01 Section 73 Issue 25.05.23

ACS Hillingdon - Sports Hall

extension

689 IID PL XX DR A-1002 P01

Existing Sports Hall Proposed Roof Layout

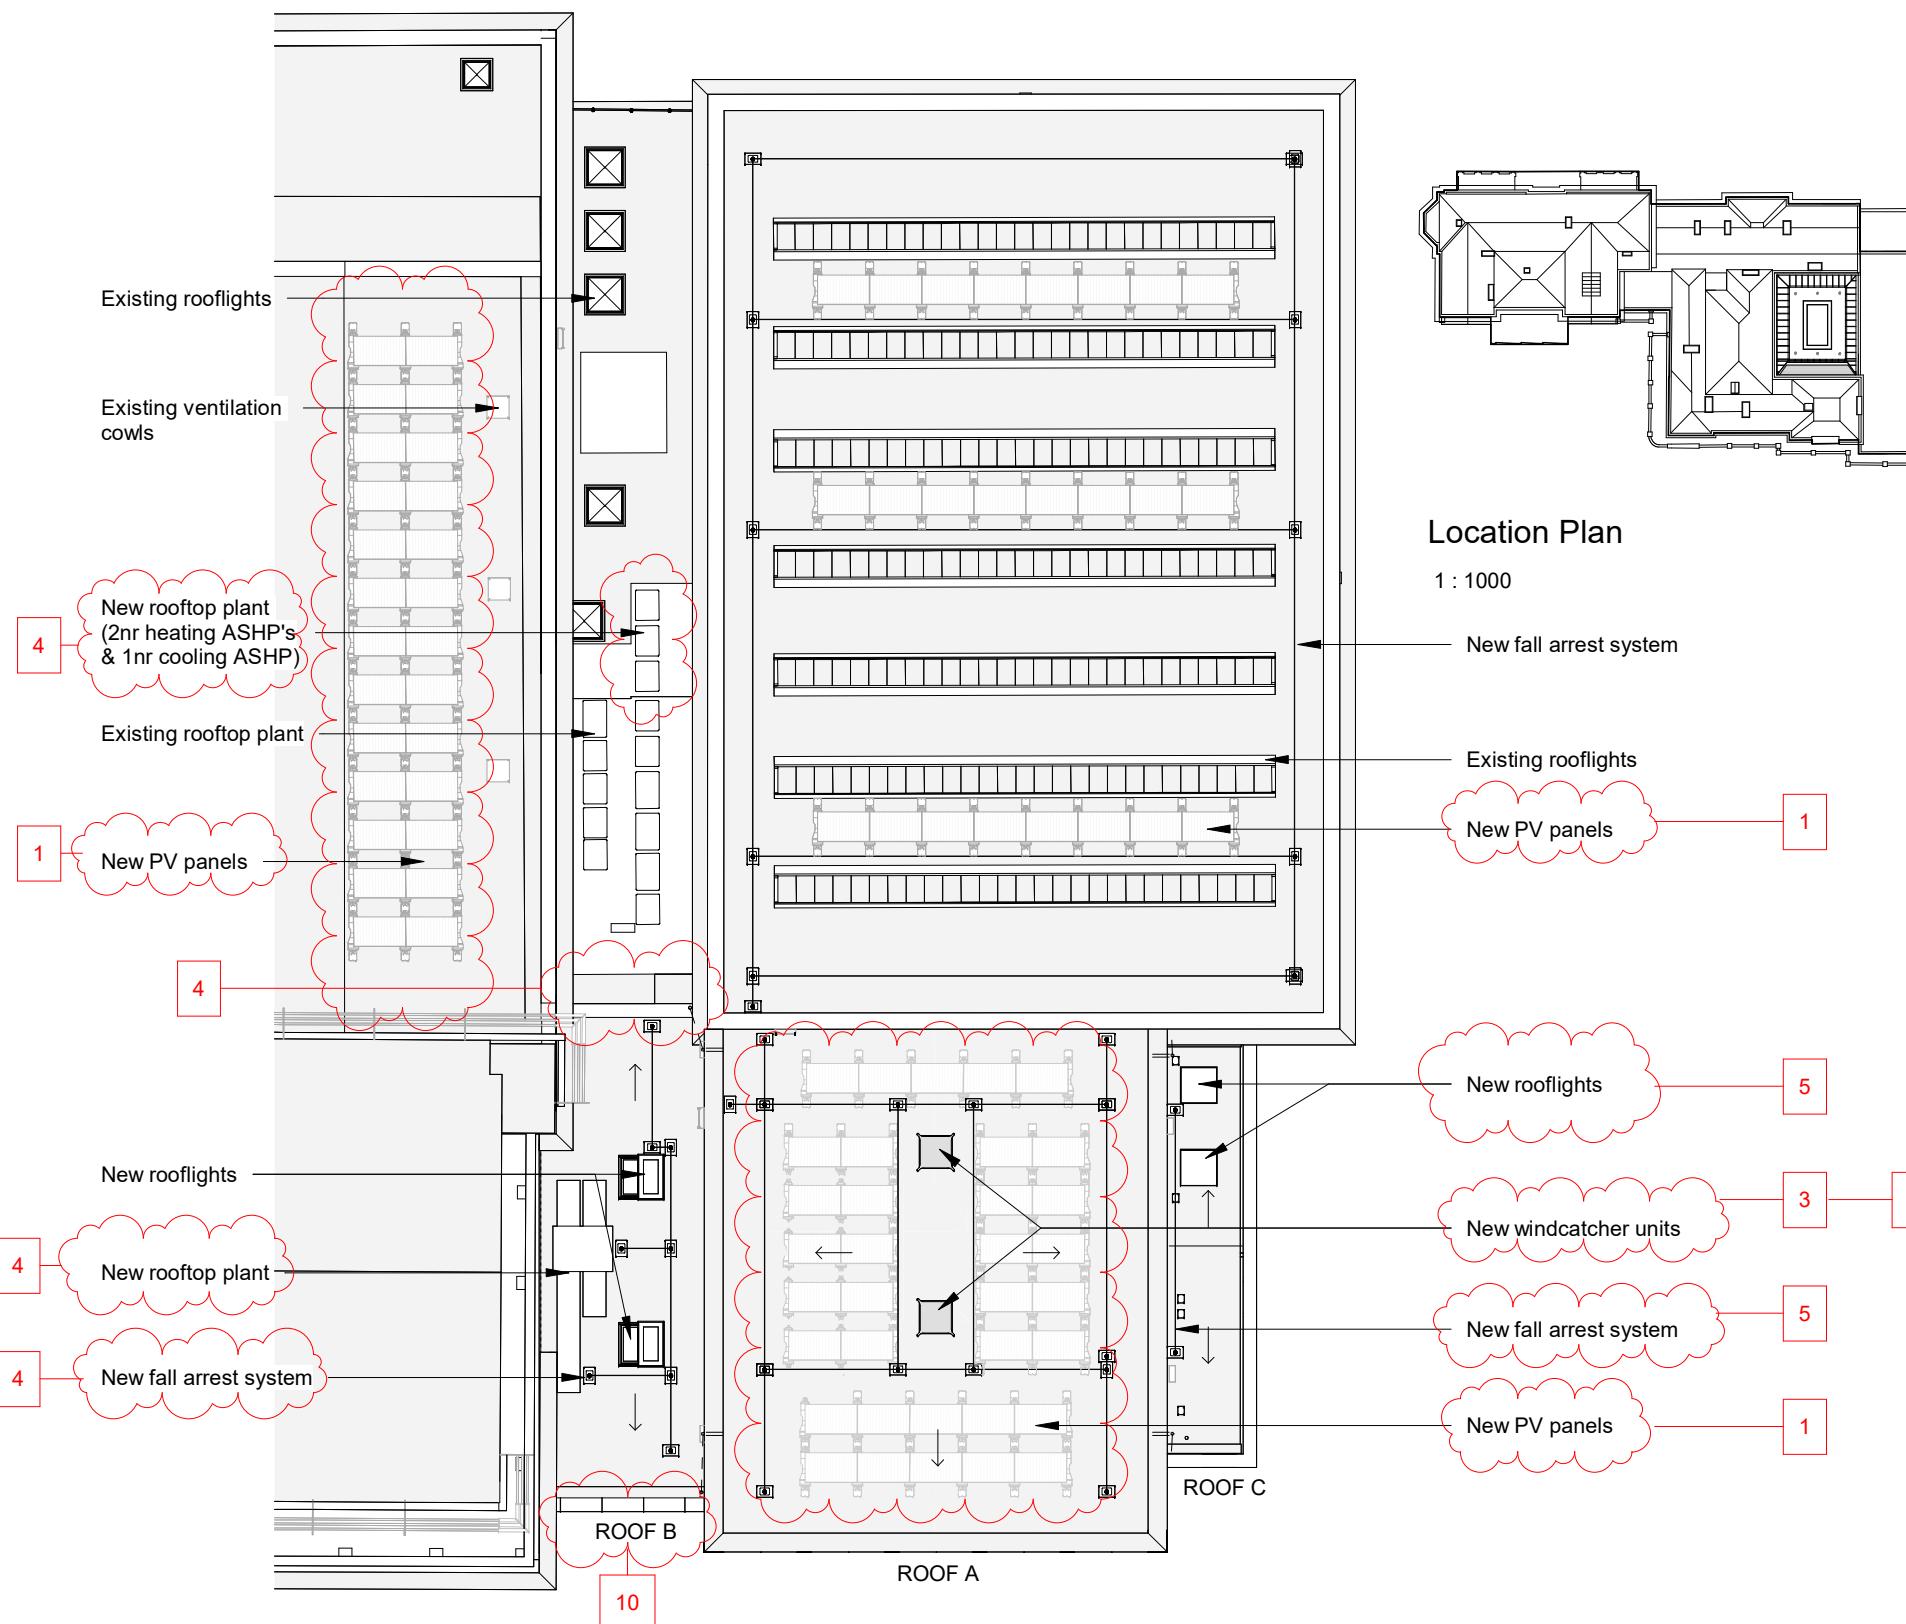
New fall arrest system

New PV panels

DRAWING TITLE
Proposed Science Extension
North and South Elevations

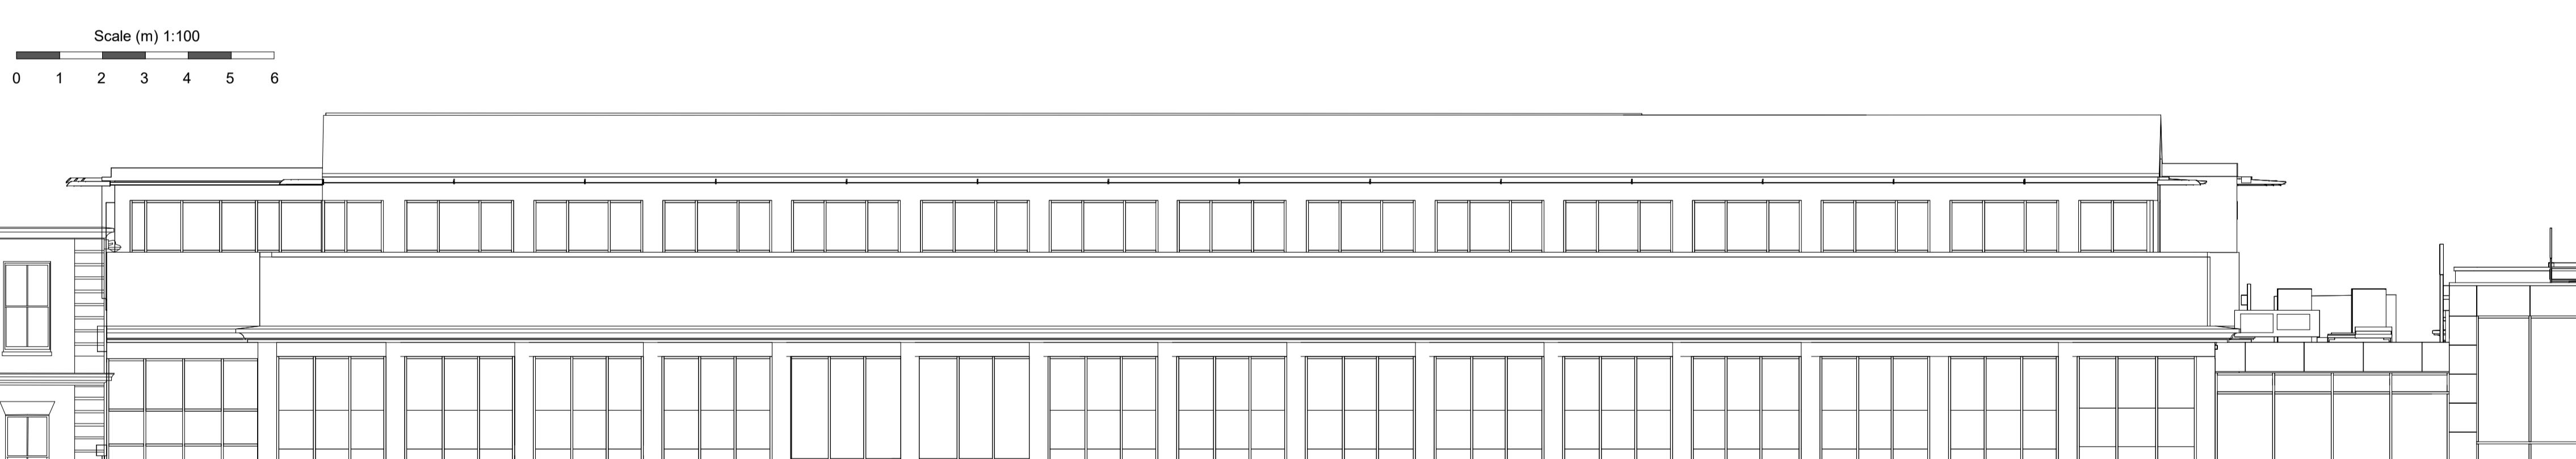
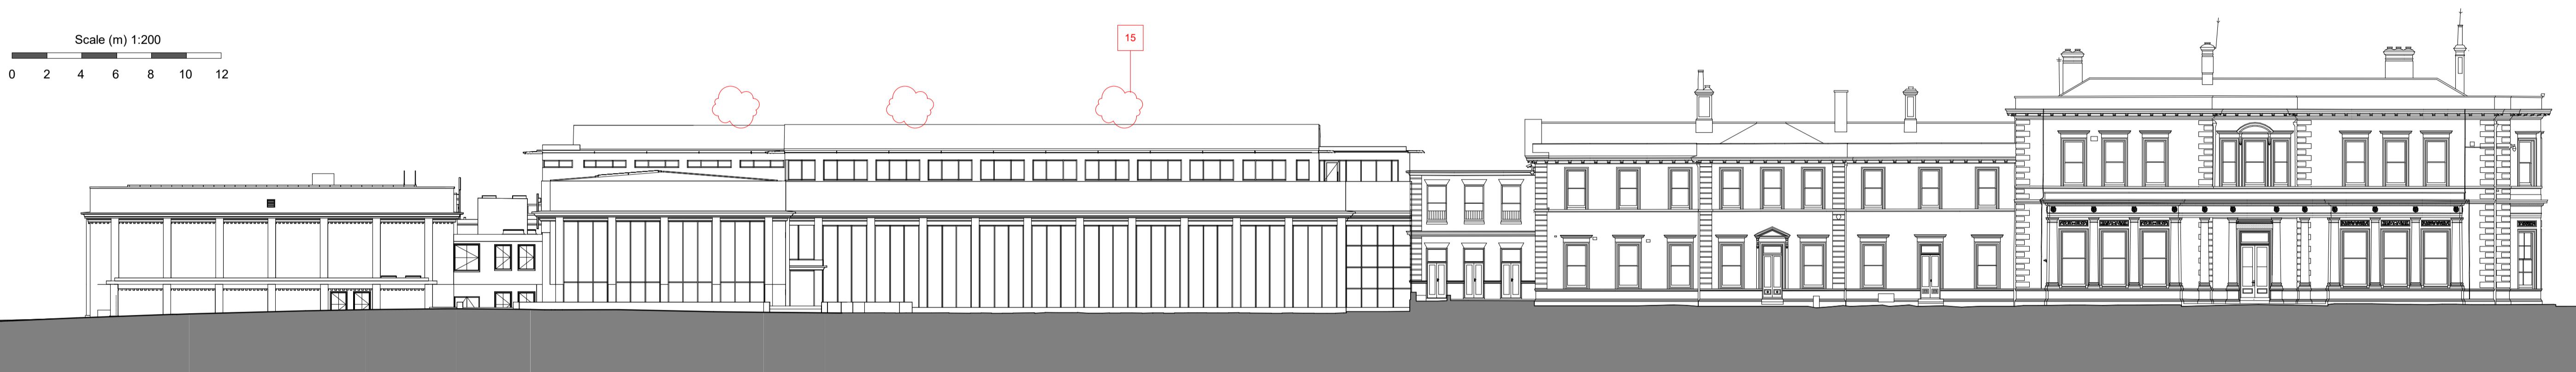
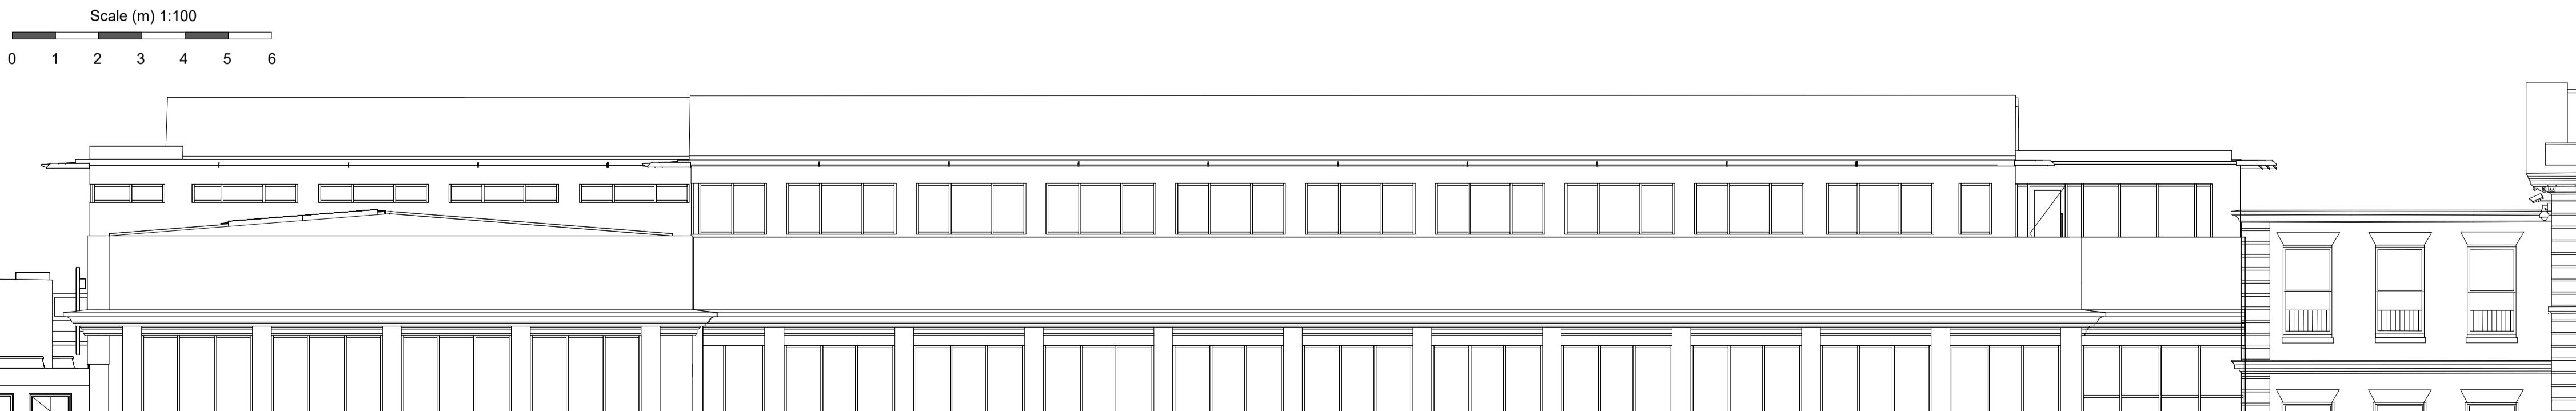
See Above Markup

See Above Markup
